Addendum

Reconstruction at
Mahopac High School
Mahopac Middle School
Mahopac Falls School
Bus Garage
New Pump House

BID Addendum No. 3
to
Drawings and Project Manual

February 22, 2021

First Floor Power Plan

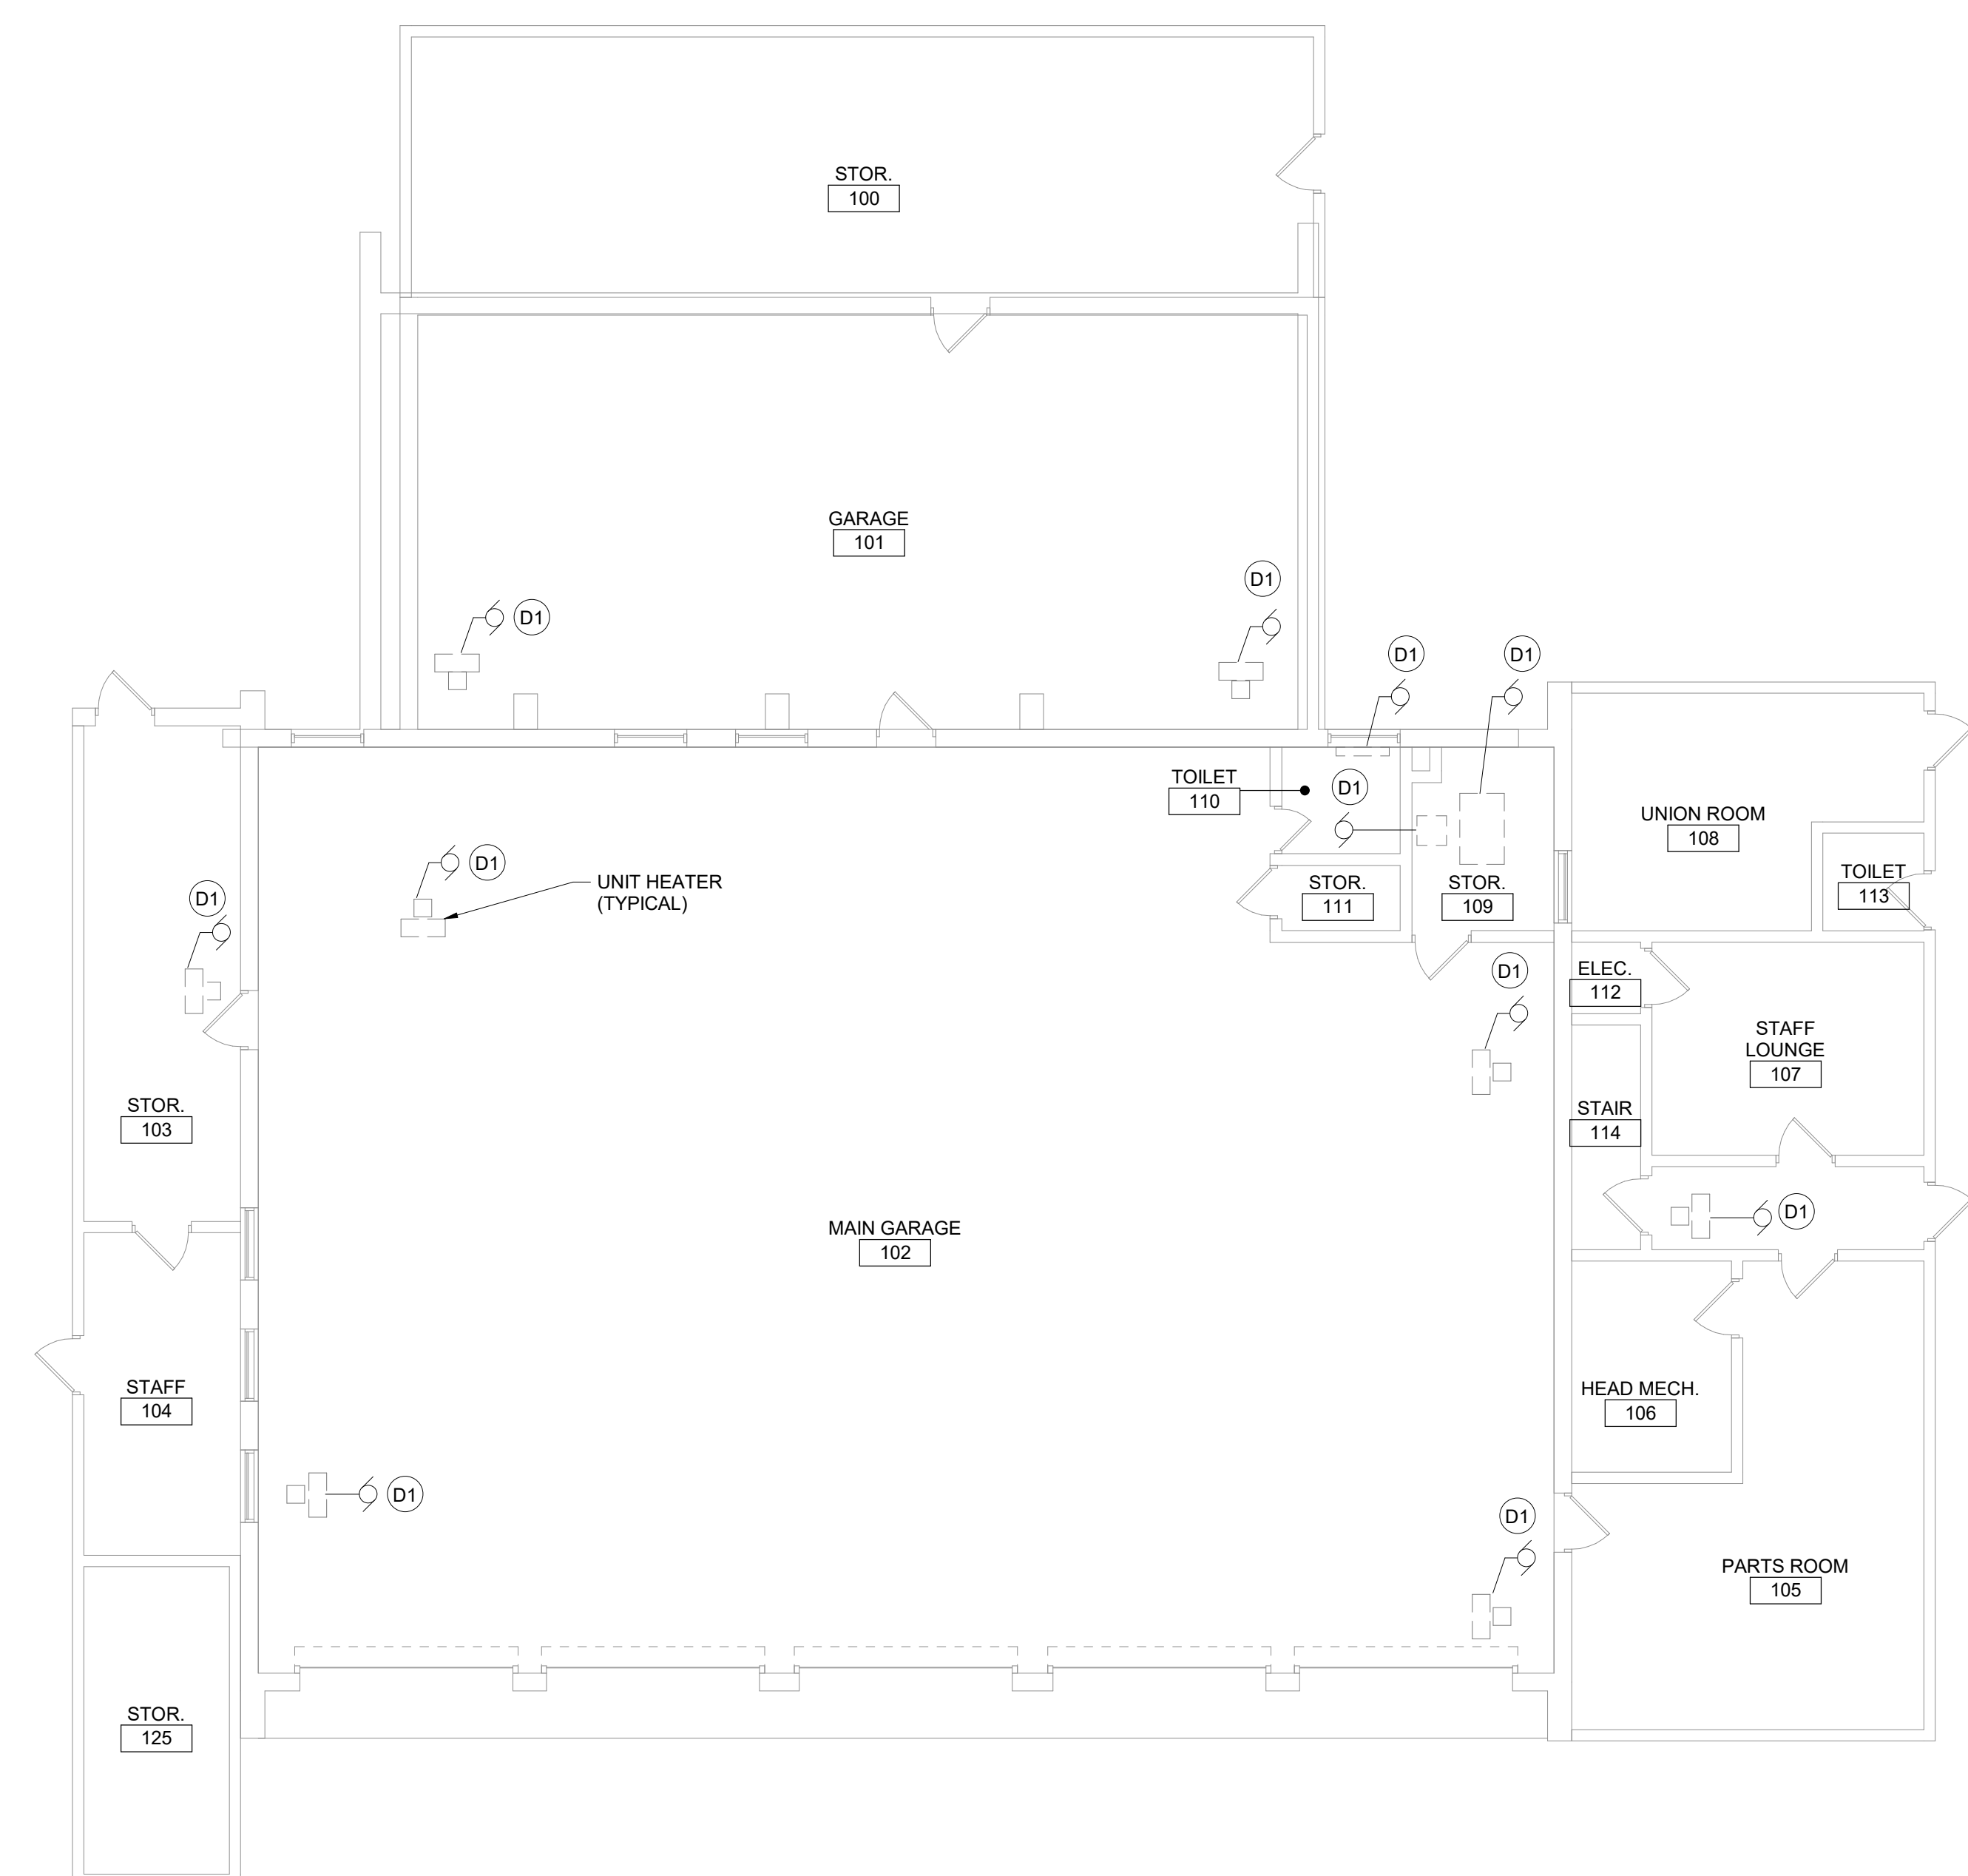
Question: (Please be specific) 1. confirm that disconnects per note 1 on this plan is the only scope of work here. It appears that when looking at Highschool drawing AE003 the feed to the pump house comes from the elementary school not the highschool, please confirm . AE700 also shows feed to pumphouse coming from the Highschool MDP, please provide correct drawing AE003 showing the route from the pumphouse to the highschool MDP location?
2. FE160 demo notes A-F mention demolition of lights, devices, disposl of lights with PCB. Can you provide plans that show lights to removed and which will need pcb removal? Or are these notes not part of the scope, please confirm scope of work at Elementary school?

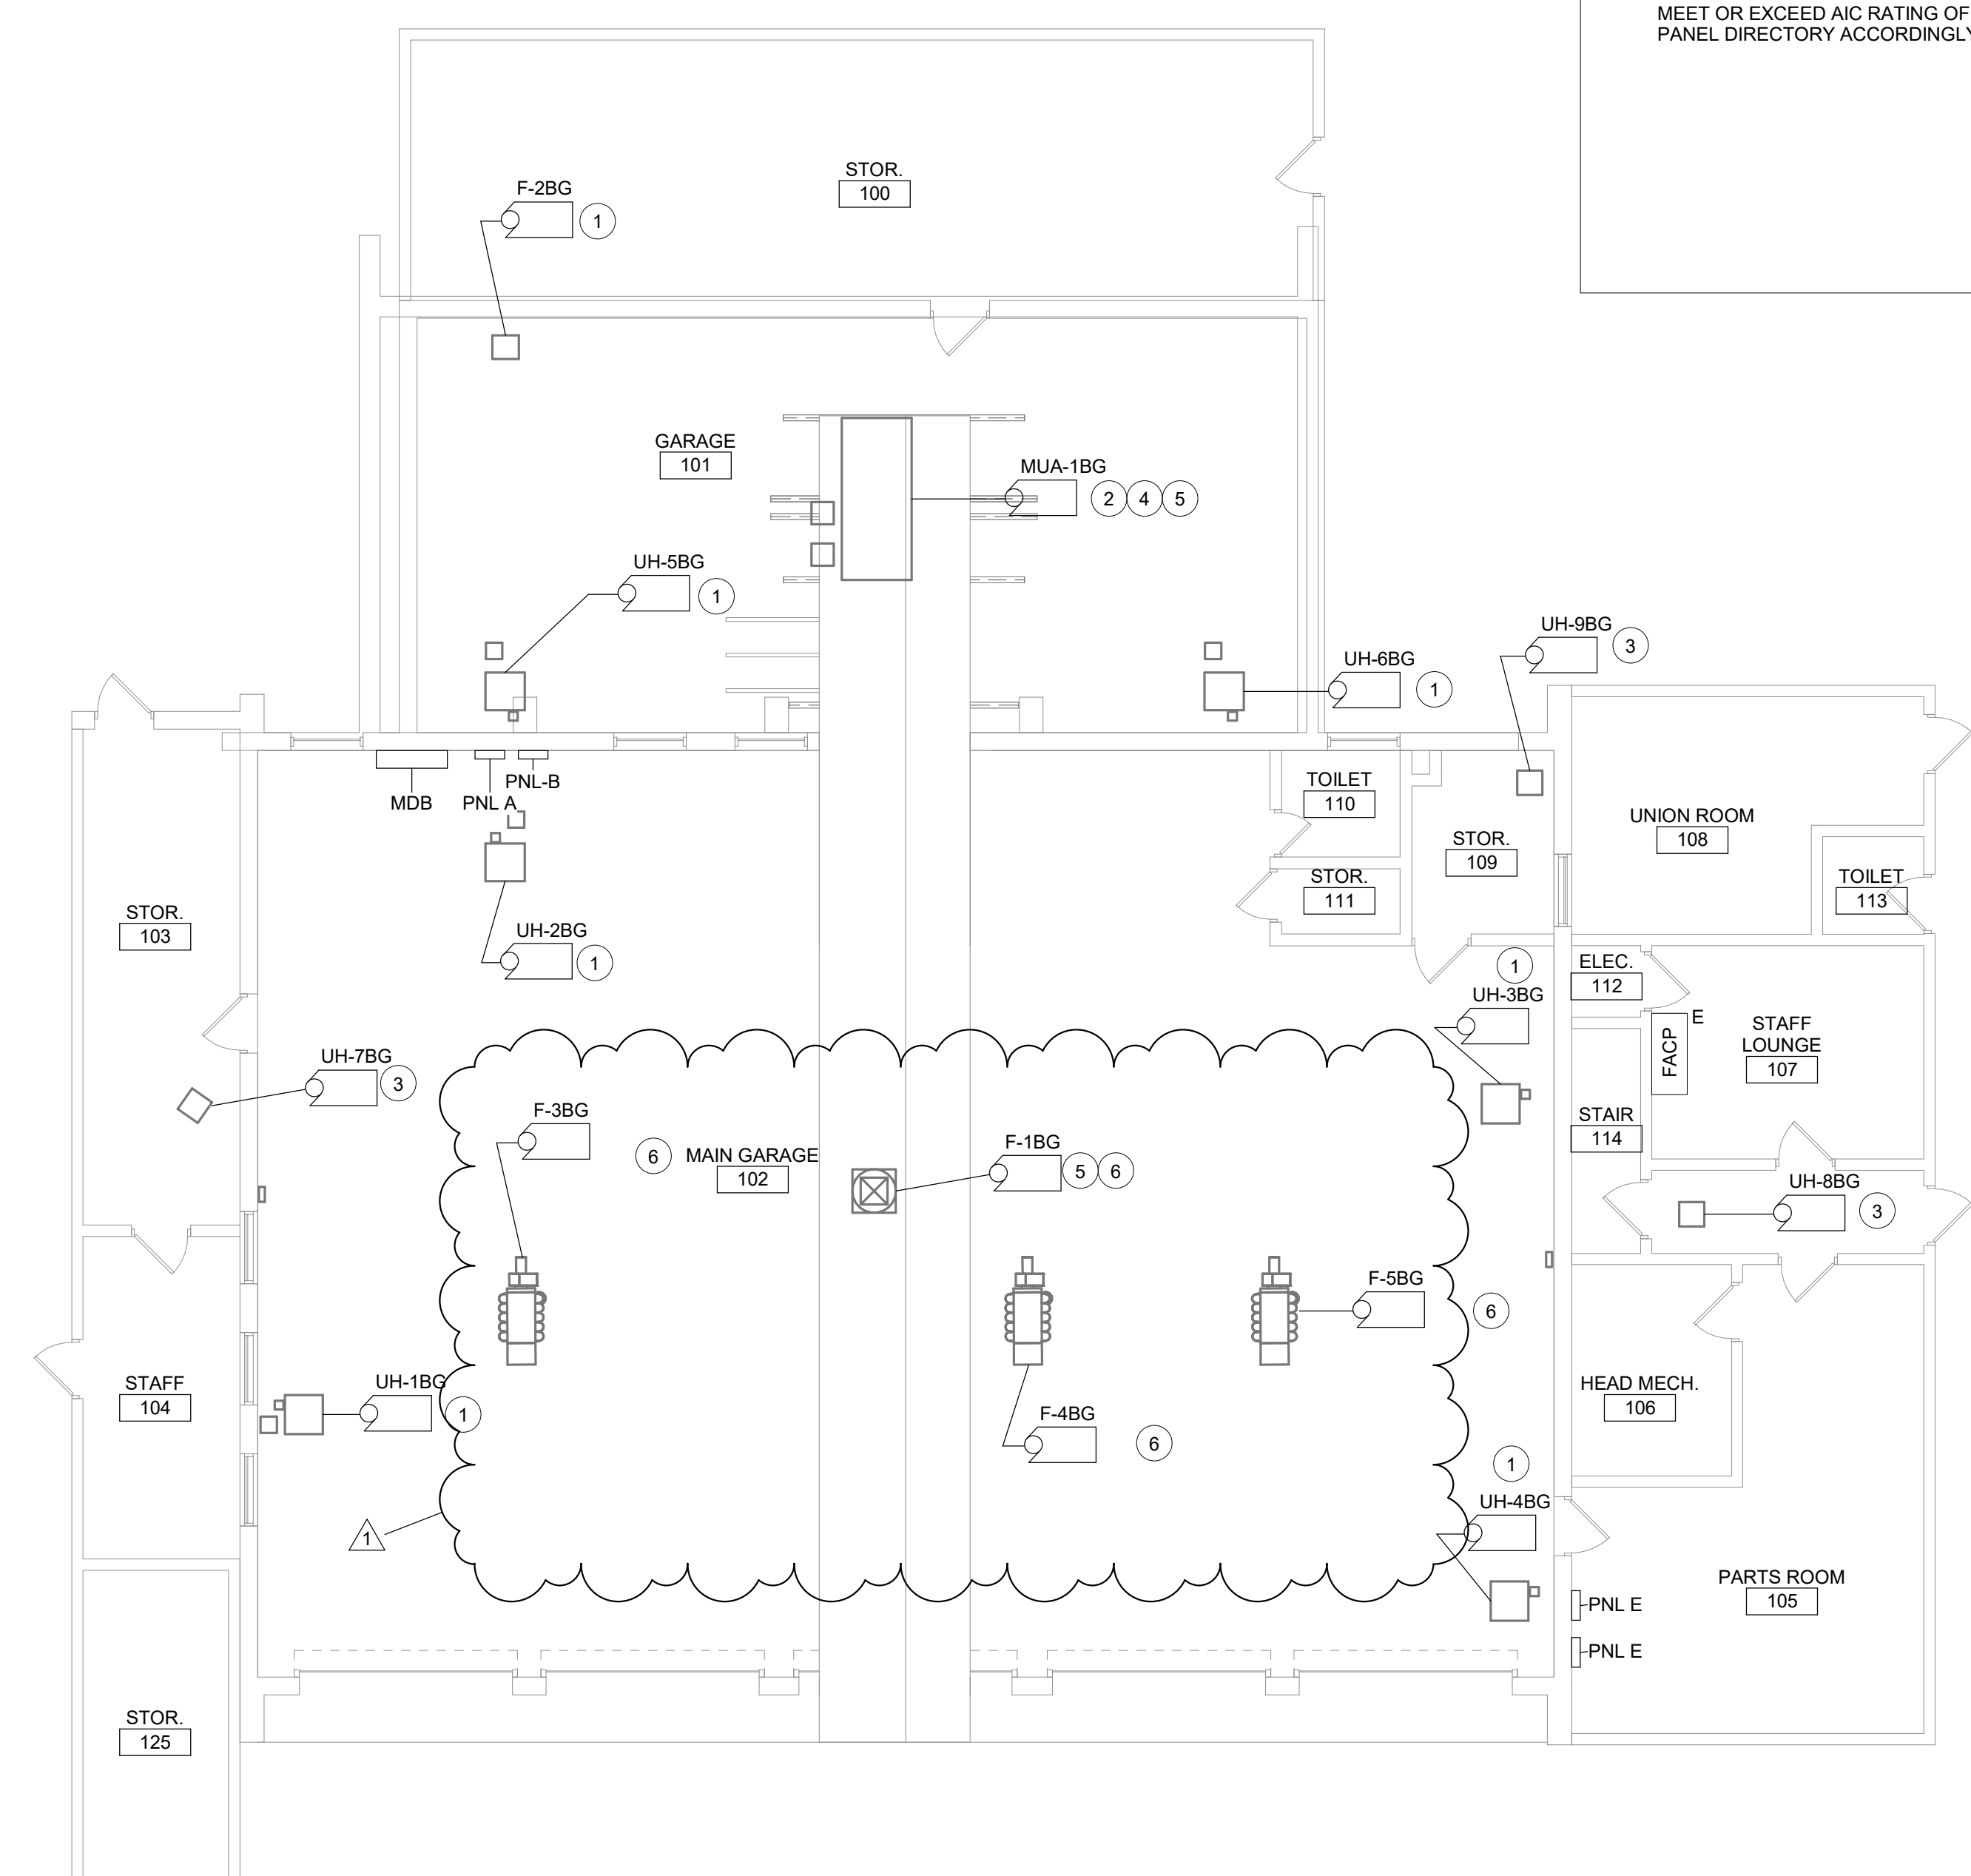
Question: (Please be specific) 1. Fan units show both notes 1 & 6 which state 2 different feeder sizes, can you confirm which feeder size we need to use for units F-4BG, F-1BG, F-3BG, which shown both notes 1 & 6, please clarify?
